SUB-COMMITTEE ON POLLUTION
PREVENTION AND RESPONSE
4th session
Agenda item 6

PPR 4/6
14 October 2016
Original: ENGLISH

REVISED GUIDANCE ON BALLAST WATER SAMPLING AND ANALYSIS

Proposal for amendments to the Guidelines on ballast water sampling (G2) to incorporate standard sample port and relieve ships from designing and installing sample probes

Figure 1: Supply and return sample port arrangement

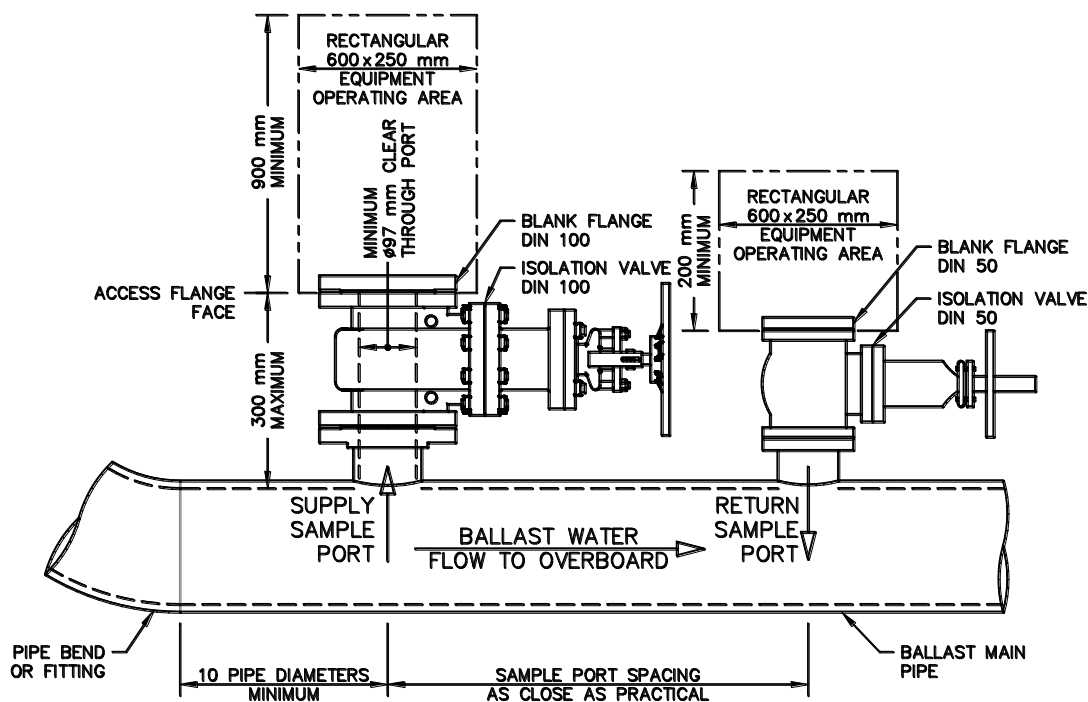
1.1 There shall be two (2) sample port connections. One (1) shall be the supply sample port connection. One (1) shall be the return sample port connection.

1.2 The supply sample port connection shall be located upstream of the return sample port connection. The supply and return connections shall be located as close to each other as practical.

2.1 A pipe boss, saddle, or other approved method of DIN 100 dimensions shall be used to access the inside of the ballast main pipe. The inside of the access shall be unobstructed by the ballast main pipe with internal edges smoothed and de-burred.

2.2 The clear inside diameter of the sample port assembly, including valve, piping, and flanges, shall be a minimum of 97.0 mm, corresponding to the inside diameter of 100 DIN extra-strong schedule pipe.

2.3 An isolation valve of DIN 100 dimensions shall be provided to allow the sample port to be closed off from the ballast main pipe. The isolation valve shall be fully ported, such that a clear and straight opening of not less than 97.0 mm diameter is provided from the access flange into the ballast main pipe when the valve is fully open. Suitable isolation valves include fully ported ball valves and gate valves. Butterfly, globe, and similar valves that do not provide a clear and straight opening are not acceptable.

2.4 An access flange of DIN 100 dimensions shall be provided to allow connection of a sample collection device by others to the supply sample port. The access flange shall be of standard design to ANSI B16.5 class 150 or DIN 2544 PN25, which are identical dimensionally. It is acceptable to utilize a flanged isolation valve as the access flange provided it meets the ANSI or DIN standard. The access flange should be paired with a blank flange, gasket, and bolting suitable to close the sample port when not in use. The access flange shall be maintained and fitted with appropriate gaskets and fasteners so that that a sample collection device attached by others can achieve a tight seal.

2.5 The distance from the ballast main pipe inside diameter to the face of the access flange shall not exceed 300 mm.

3.1 A pipe boss, saddle, or other approved method of DIN 50 dimensions shall be used to access the inside of the ballast main pipe. The inside of the access shall be unobstructed by the ballast main pipe with internal edges smoothed and de-burred.

3.2 An isolation valve of DIN 50 dimensions shall be provided to allow the return sample port to be closed off from the ballast main pipe.

3.3 An access flange of DIN 50 dimensions shall be provided to allow connection of a sample collection device by others to the return sample port. The access flange shall be of standard design to ANSI B16.5 class 150 or DIN 2544 PN25, which are identical dimensionally. It is acceptable to utilize a flanged isolation valve as the access flange. The access flange must be paired with a blank flange, gasket, and bolting suitable to close the sample port. The access flange must be maintained such that testing gaskets can fit tightly when sampling equipment by others is attached.
